WELL API NO. 30-015-24972
5. Indicate Type of Lease STATE <input checked="" type="checkbox"/> FEE <input type="checkbox"/>
6. State Oil & Gas Lease No.
7. Lease Name or Unit Agreement Name WHITE BABY COM.
8. Well Number 002
9. OGRID Number 162683
10. Pool name or Wildcat WHITE CITY (PENN)

SUNDRY NOTICES AND REPORTS ON WELLS
 (DO NOT USE THIS FORM FOR PROPOSALS TO DRILL OR TO DEEPEN OR PLUG BACK TO A DIFFERENT RESERVOIR. USE "APPLICATION FOR PERMIT" (FORM C-101) FOR SUCH PROPOSALS.)

White Baby Com #2

CONDITIONS FOR PLUGGING AND ABANDONMENT

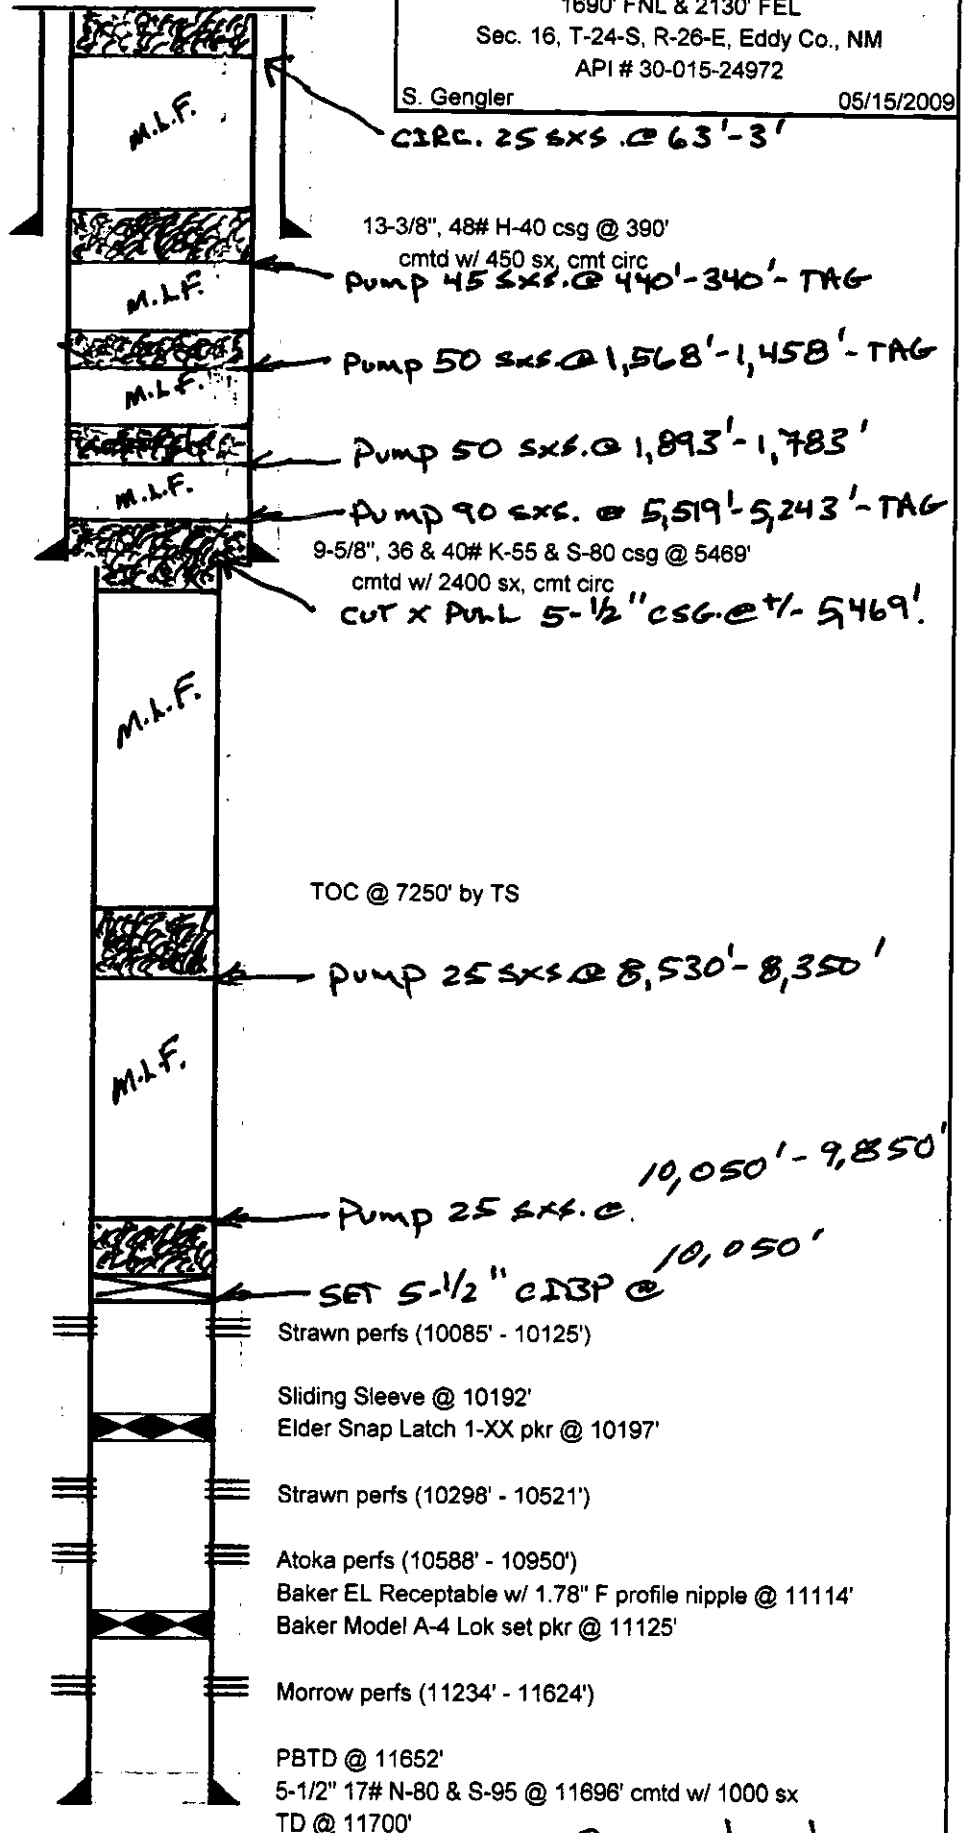
- Top Part @ 10085'*
- 1) SET 5-1/2" CIBP @ 10,050'; PUMP 25 SXS. CMT. @ 10,050'-9,850" (T/STWN.); CIRC. WELL W/ M.L.F. - woc & Tag
 - 2) PUMP 25 SXS. CMT. @ 8,530'-8,350' (T/WCMP.).
 - 3) CUT X PULL 5-1/2" CSG. @ +/-5,469'.
 - 4) PUMP 90 SXS. CMT. @ 5,519'-5,243' (5-1/2" CSG.STUB, 9-5/8" CSG.SHOE, T/BNSG.); WOC X TAG CMT. PLUG.
 - 5) PUMP 50 SXS. CMT. @ 1,893'-1,783' (T/DLWR.).
 - 6) PUMP 50 SXS. CMT. @ 1,568'-1,458' (B/SALT); WOC X TAG CMT. PLUG.
 - 7) PUMP 45 SXS. CMT. @ 440'-340' (13-3/8" CSG.SHOE); WOC X TAG CMT. PLUG. - *part @ 440'*
 - 8) CIRC. 25 SXS. CMT. @ 83'-3'. - *part @ 150' - cut to 5'*
 - 9) DIG OUT X CUT OFF WELLHEAD 3' BGL; WELD ON STEEL PLATE TO CSGS X INSTALL DRY HOLE MARKER.

**See Attached COAs*

Must be Plugged by 4/2/20
